AS CONSTRUCTED PLANS

PROJECT NO. : 8 11 50 701
F.A. NO. : FBDNHS-306(001)
T.I.P. NO. : F-2800
COUNTY : BEAUFORT
DESCRIPTION : Pamlico River Ferry Basin Ramps ON
NC-306 Between Aurora and Both.
DIVISION NO. : TWO
CONTRACTOR : HMG, INC.
812 N. ELM ST.
GREENSBORO, NC 27401
DIVISION ENGINEER : MR. G.R. SHIRLEY, JR., P.E.
RESIDENT ENGINEER : MR. J.A. WOLF, JR., P.E.

LOCATION : N.C. 306 AT PAMLICO RIVER FERRY
 TYPE OF WORK : GRADING, PAVING, BULKHEAD REPLACEMENT,
 RECONSTRUCTION OF FERRY RAMPS, AND STRUCTURES

STATE OF NORTH CAROLINA
DEPARTMENT OF TRANSPORTATION
RALEIGH
PAMLICO RIVER FERRY
NORTH RAMP AND SOUTH
RAMP

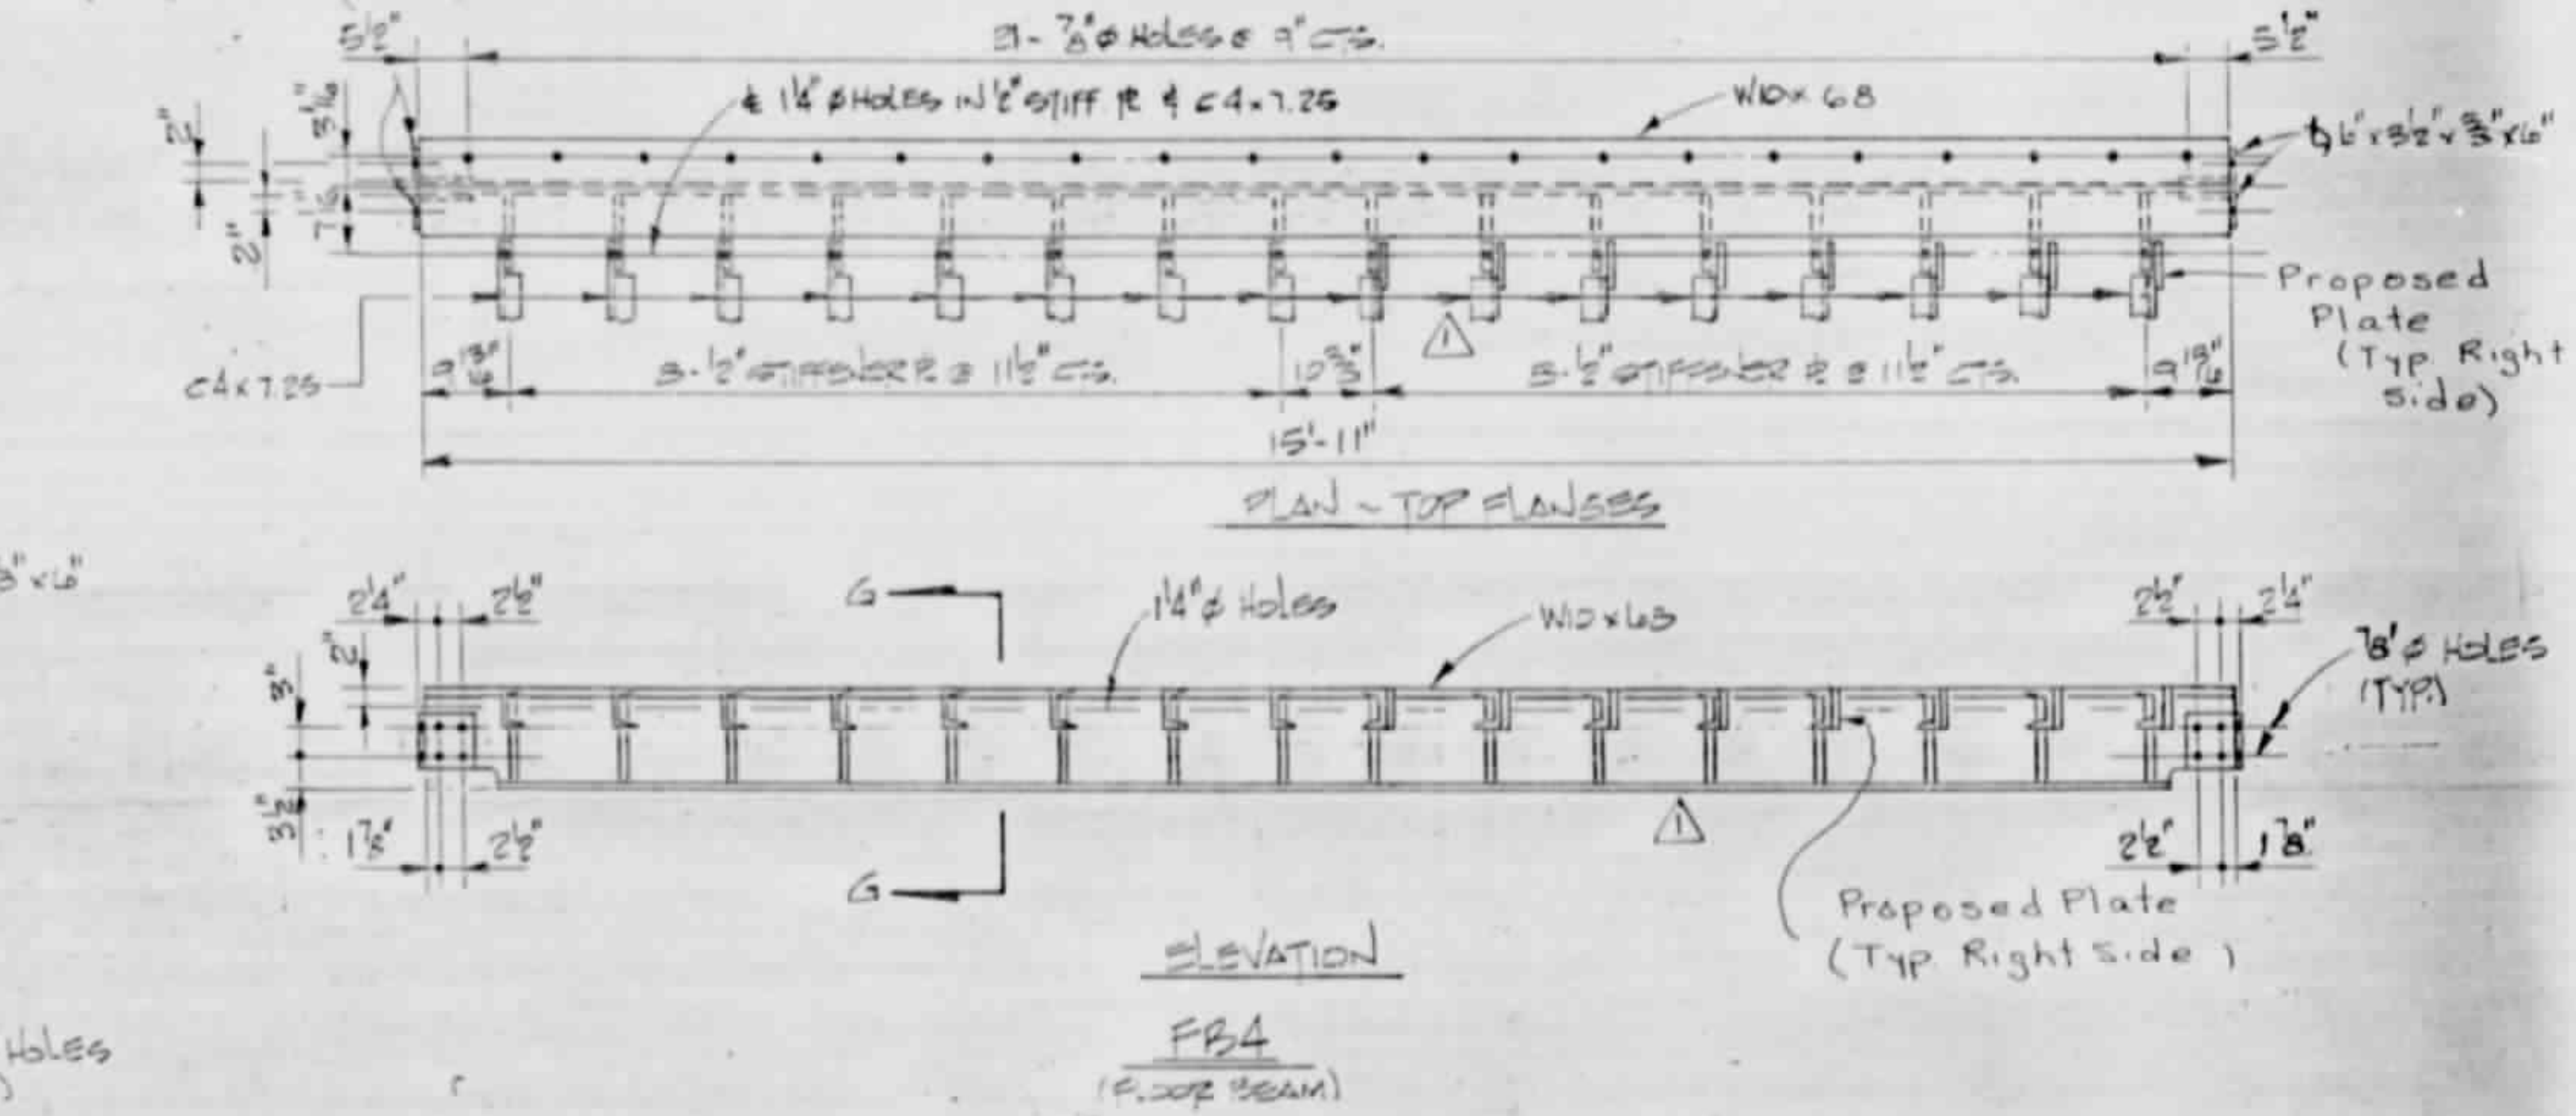
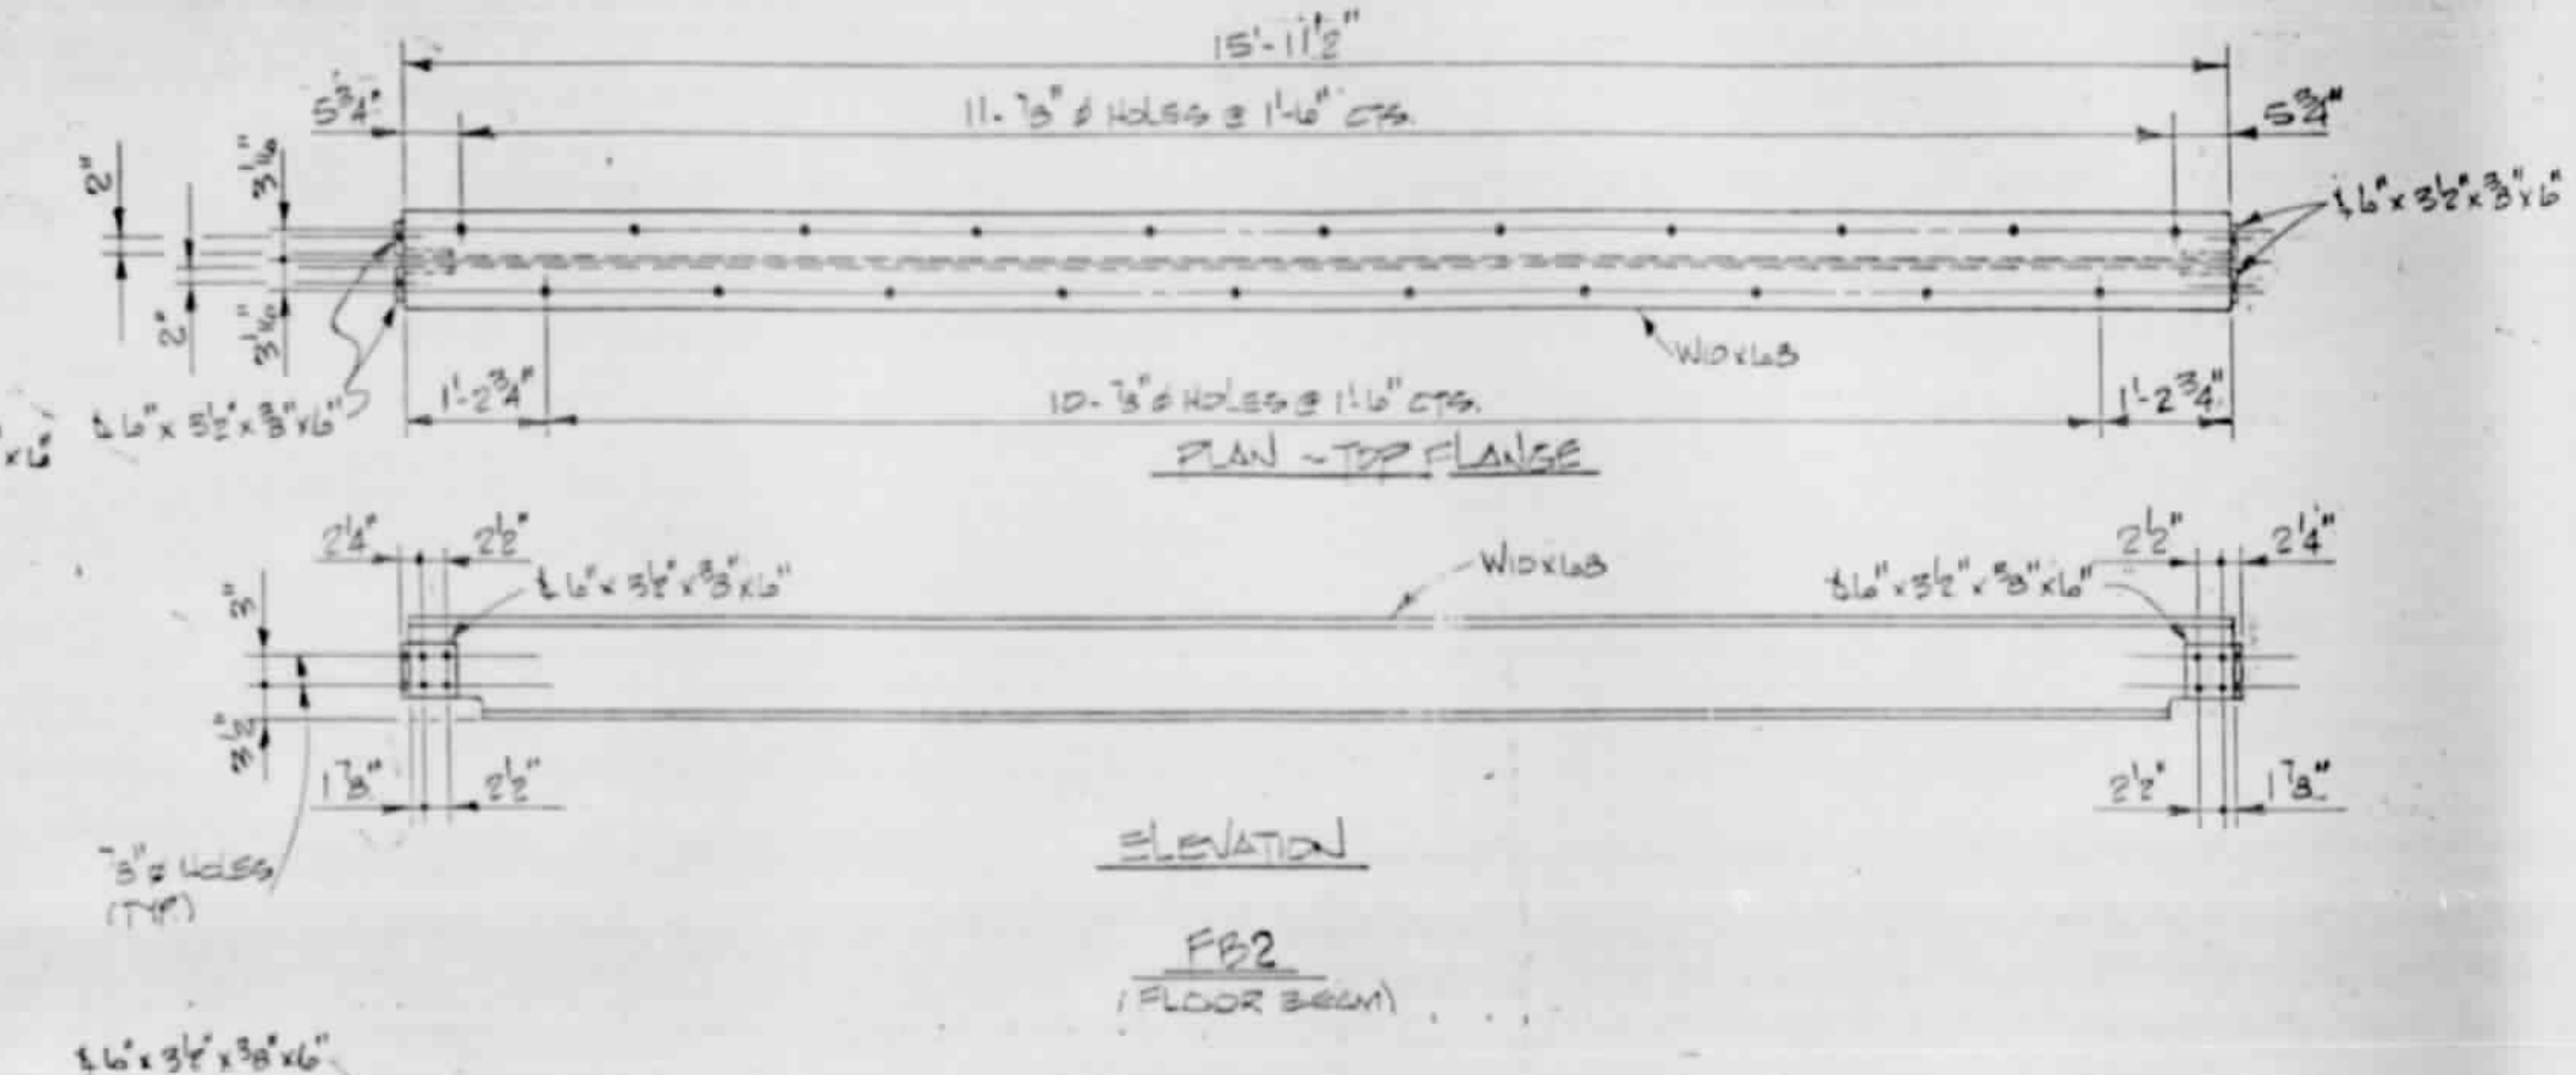
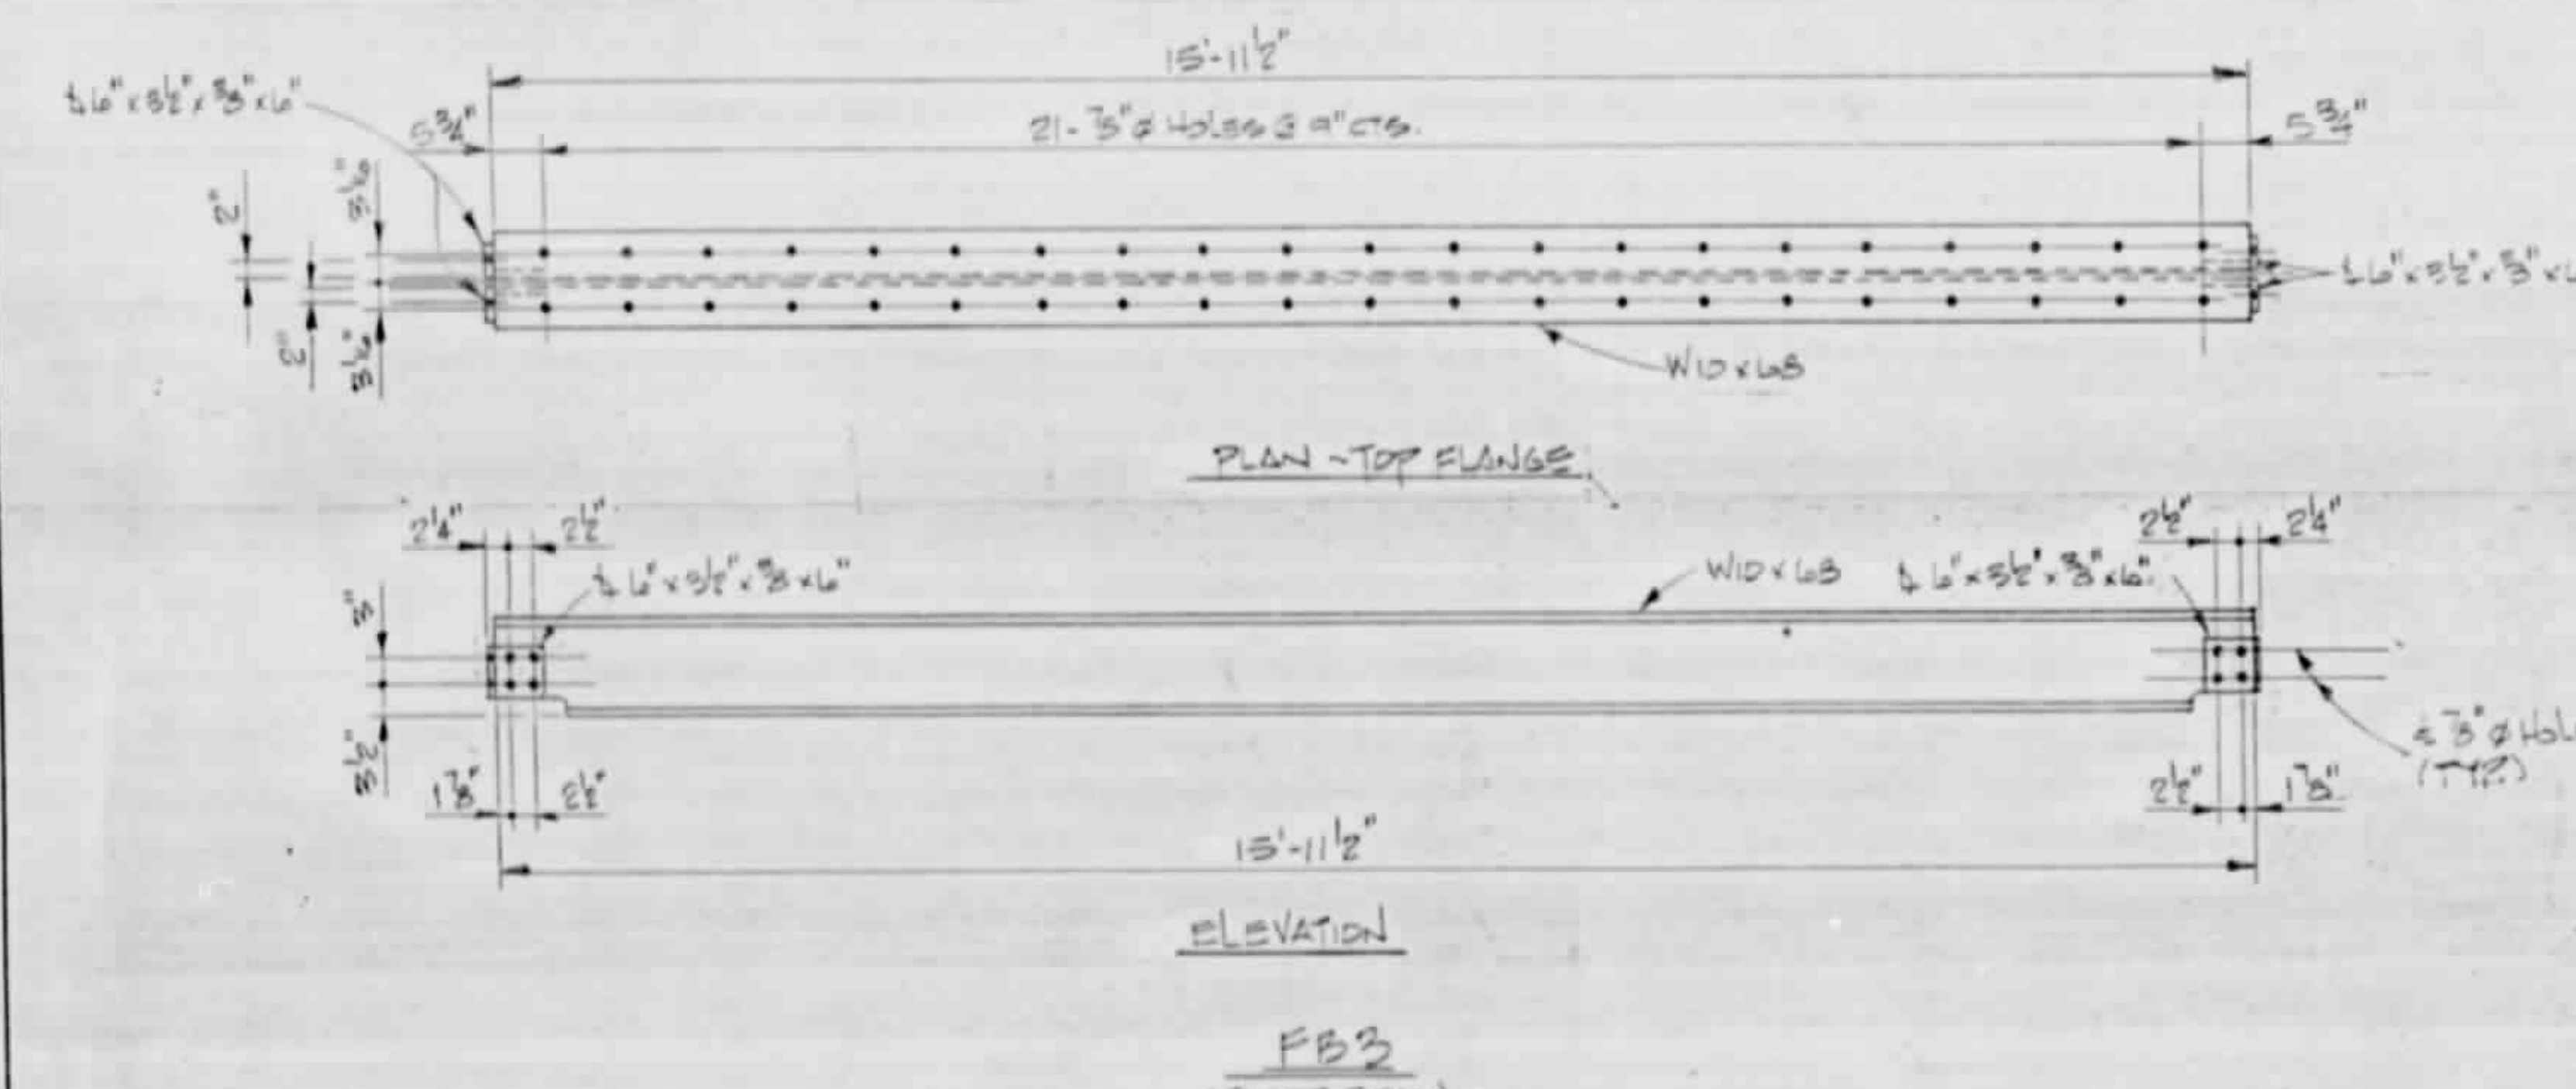
Rev No. 1 Revised right hand side of Plan and Elevation of FB4 To Show Proposed Plate. Drawn By: FAM / By: PEK
